PLAN SNAPSHOT REPORT DSIAPP-000338-2026 FOR CITY OF SAINT PAUL

Description: An appeal of a appeal of a decision by the Board of Zoning Appeals denying two variances from the design standards of City Council Resolution 23-1442 for a development project at United Village Block D, where new commercial buildings facing arterial streets such as University Avenue are required to provide window and door openings comprising at least 50% of the ground-floor façade length and 30% of the ground-floor façade area, and the proposed hotel's north façade includes 43.1% of the façade length and 23.3% of the façade area as window and door openings, for variances of 6.9% and 6.7%

Zoning Variance Application United Village Block D (Hotel)

TYPE OF APPLICATION: Major Variance **FILE #: DSIBZA-000290-2026**

A-1

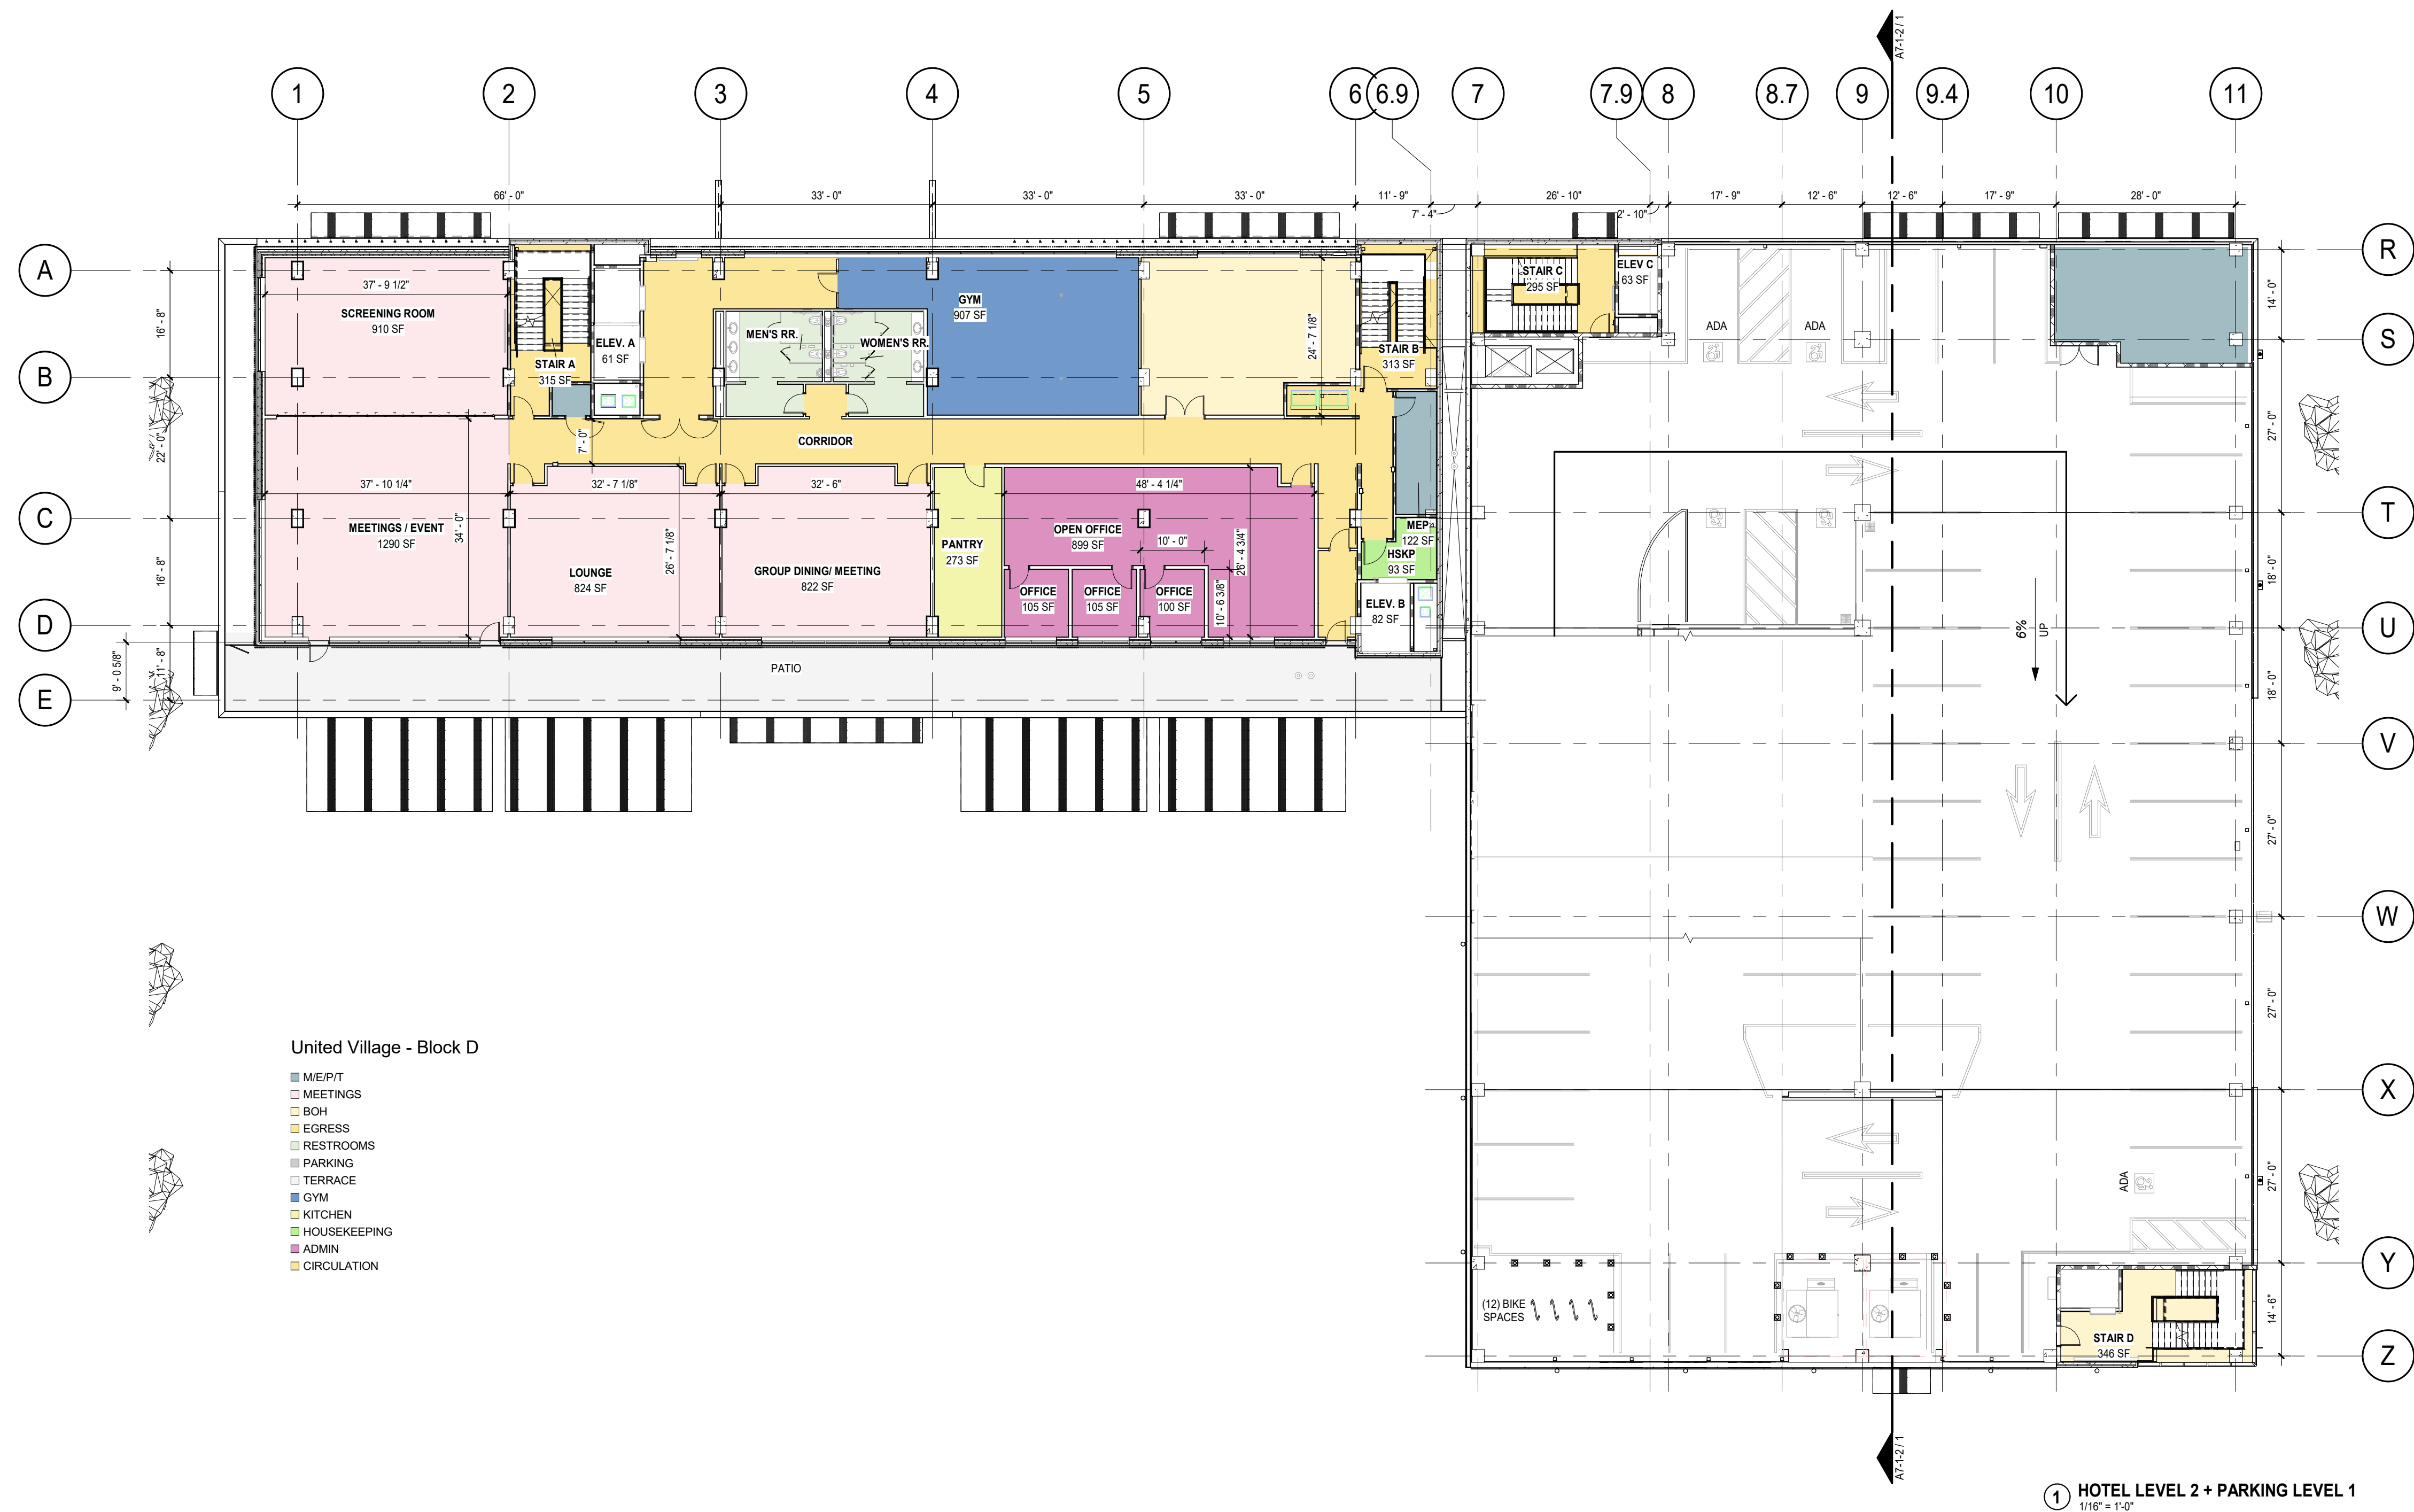
1. The variance is in harmony with the general purposes and intent of the zoning code.
 - A. This variance is consistent with the overall purpose and intent of the code, as the proposed window and door openings provide meaningful visual connections from the pedestrian realm into active interior public spaces, including the retail area, guest amenity spaces (e.g. library and wine rooms), and the main hotel lobby. The exterior design avoids placing windows at the NW and NE restrooms and back of house spaces along this façade.

- B. Refer to Sheet A-1 for first floor plan layout.
2. The variance is consistent with the comprehensive plan.
 - A. The variance is consistent with the intent of the T4 Traditional Neighborhood District, as the project provides a pedestrian-oriented, mixed-use development within a transit-supportive neighborhood. Because the hotel and parking ramp occupy an entire city block and are bordered by streets on all four sides, some back-of-house functions must be located along portions of the exterior perimeter. Even so, as illustrated on the attached exterior elevations, each façade incorporates a thoughtful composition of brick, precast, windows, and openings that maintains a meaningful pedestrian connection. In addition, strategically placed art murals along the north, west, and south elevations reinforce this interaction. Together, these architectural elements and public art features enhance the pedestrian experience and contribute to an active, engaging streetscape

② NORTH ELEVATION - VARIANCE DIAGRAM
1/16" = 1'-0"

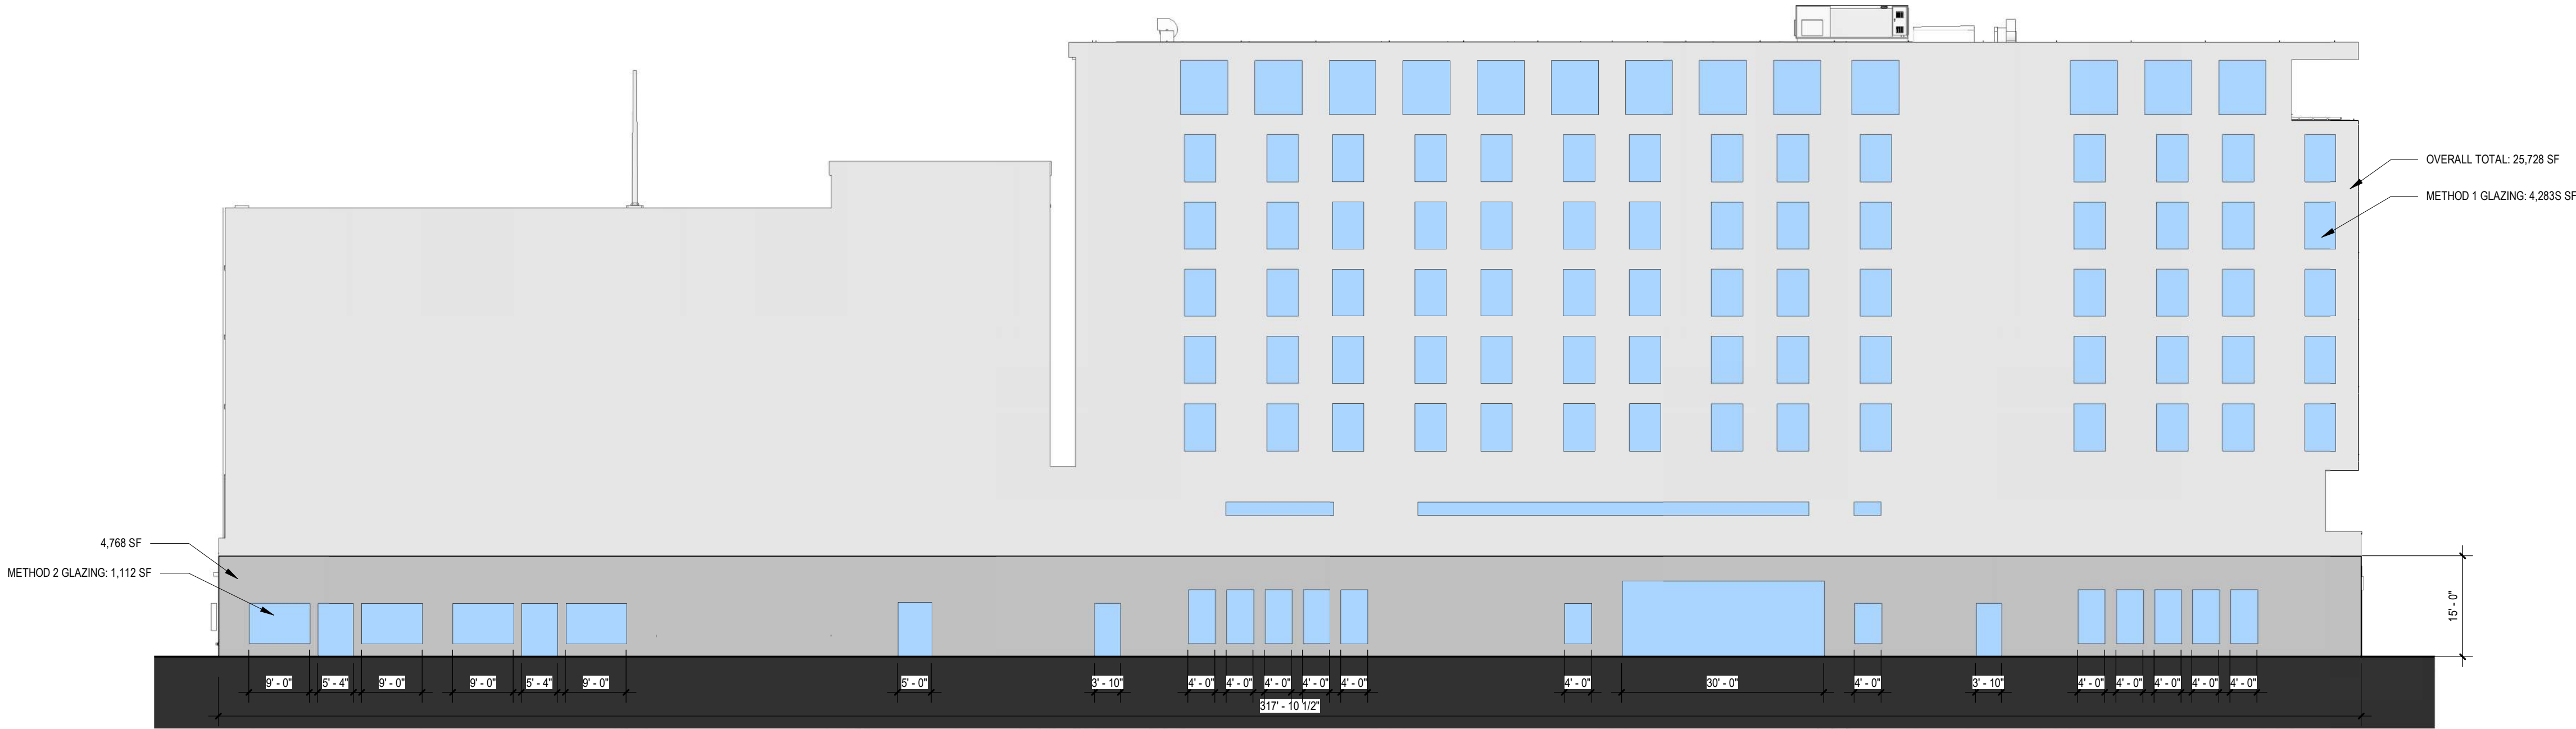
- A. For the north elevation of the hotel, the window and door openings comprise approximately 43.1% of the total length and 23.3% of the area of the ground floor. The floor plan layout along the north portion of this floor level is a combination of hotel guest areas more centrally located around the main lobby along with amenity / support spaces of the hotel. This is consistent with the typical circulation and operation of the hotel. The addition of more openings would not provide any visual connection to the public areas of the hotel and thus conflict with the intent of the zoning requirement.

C. Refer to Sheet A-12 for “opening” calculations for this elevation.

Comprehensive Façade	METHOD 1 - 63.110 (B)	NORTH University Ave	SF
General building design standards. For principal buildings above grade window and door openings shall comprise at least fifteen (15) percent of the total area of exterior walls facing a public street or sidewalk.		Entire Façade	25,728 SF
		Glazed	4,283 SF
		Portion Glazed	16.6 %
		Requested Variance	0 %
Building base Area	METHOD 2 - Resolution 3	NORTH University Ave	SF
All new commercial and civic buildings shall have window and door openings and at least 30 percent of the area around the ground floor along arterial, collector, and/or local street facades.		Entire Façade	4,768 SF
		Glazed	1,112 SF
		Portion Glazed	23.3 %
		Requested Variance	7 %
Linear distribution along street	METHOD 3 - Resolution 3	NORTH University Ave	LF
All new commercial and civic buildings shall have window and door openings that comprise at least 50 percent of the length along ground floor		Entire Façade	318 LF

Glazed	137 LF
		Portion Glazed	43.1 %
		Requested Variance	7 %
